Errata for FM25256 & FM25L256

Errata Number 003 (all Date Codes)
Date May 3, 2005
Product Marking FM25256 and FM25L256 (all package types)

Figure 1. Write Operation Starts on 5th Clock and Completes on 8th Clock

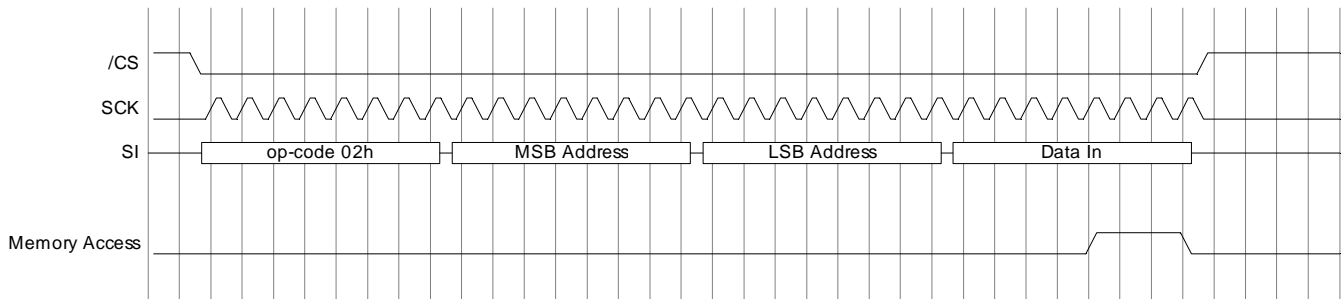
The following describes the internal operation of the 256Kbit SPI FRAM memories. These parts are designed to support serial data rates in excess of 20 MHz, however there is a limitation at very low speeds. The SPI operations are byte oriented and are initiated on the falling edge of /CS. The following diagram shows a write operation and includes the internal signal "Memory Access" to show when the memory array is accessed. For each data byte the array is accessed on the 5th clock and is closed on the 8th clock.

Figure 2. A Detailed Look at the Internal Memory Access and Timing Constraint

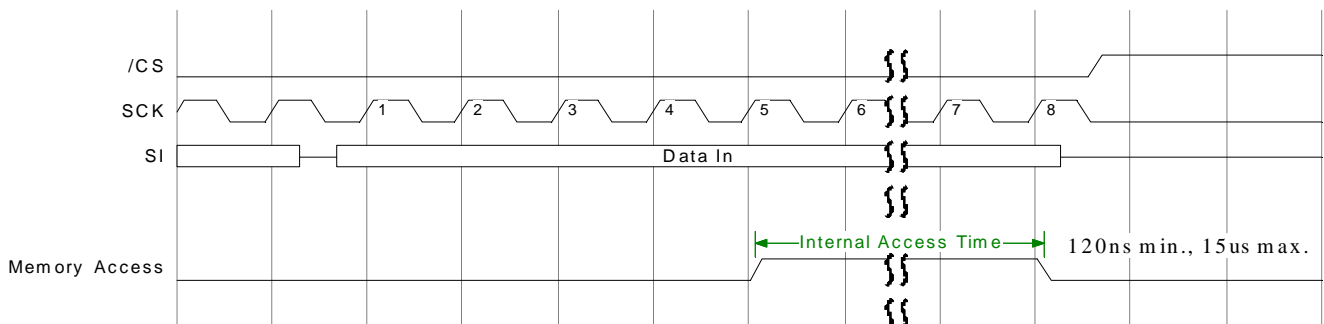
For write operations the length of time the array is being accessed is a function of clock frequency, a temporarily stopped clock, and the time /HOLD is asserted. Testing has identified an errata condition for the FM25256 and FM25L256 devices. Current product versions have a timing constraint that the user must comply with – it is labeled "Internal Access Time" in the diagram below. The minimum time is 120ns (3 clocks at 25MHz) and the maximum time is 15 μ s. The maximum time of 15 μ s is exceeded if the clock frequency is lower than 200KHz, assuming a free-running clock and the /HOLD pin is not used within the memory access period.

NOTE: The above issue will be resolved with the next die revision. Samples will be available in 3Q05.
